FEDERAL COMMUNICATIONS COMMISSION

In re: W237AT, Richmond, IN
BNPFT-20130325AMJ
Facility ID # 65509

This refers to: (1) the above-captioned application for W237AT, Richmond, Indiana.

THE FOLLOWING IS A LIST OF THE DATA WHICH APPEARS ON THE ABOVE MAP

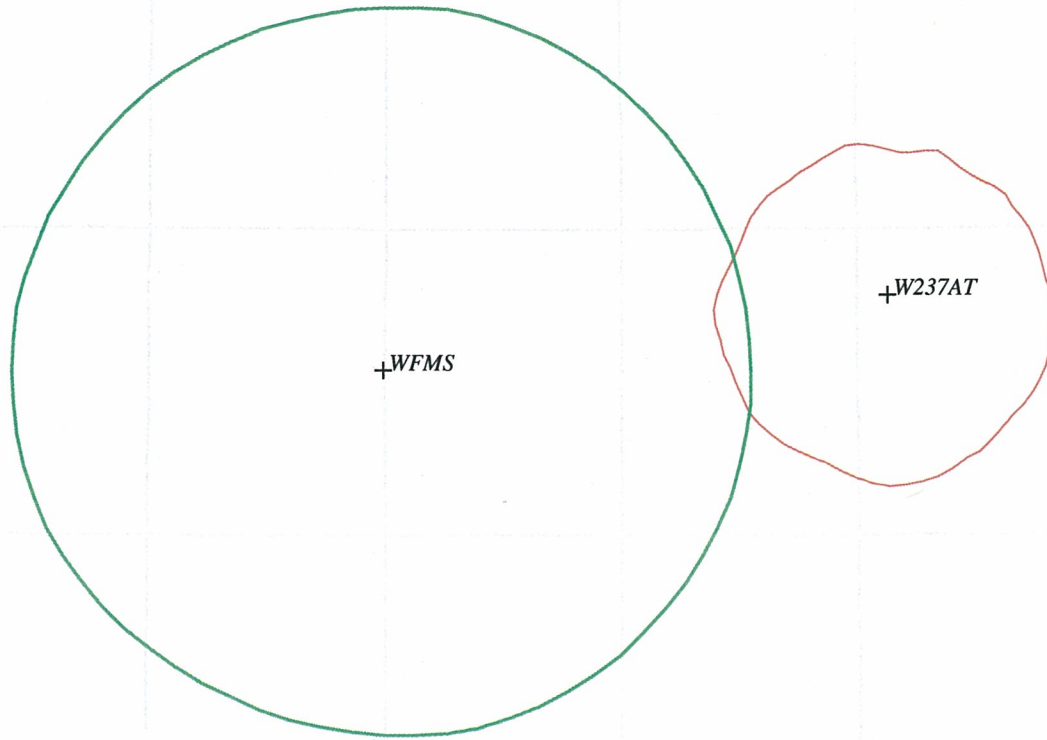
An engineering study has revealed the application violates 47 C.F.R. § 74.1204(a) with respect to WFMS(FM)¹, Fishers, Indiana. Section 74.1204(a) states that an application for a FM translator station will not be accepted if the proposed operation would involve prohibited overlap of predicted field strength contours with any other authorized station. The proposed 48 dBu interference contour overlaps with the 54 dBu protected contour of WFMS(FM). This violation was not addressed.

In light of the above, the application BNPFT-20130325AMJ filed by Brewer Broadcasting Corp. is unacceptable for filing pursuant to 47 C.F.R. § 73.3566(a) and IS HEREBY DISMISSED. This action is taken pursuant to 47 C.F.R. § 0.283.
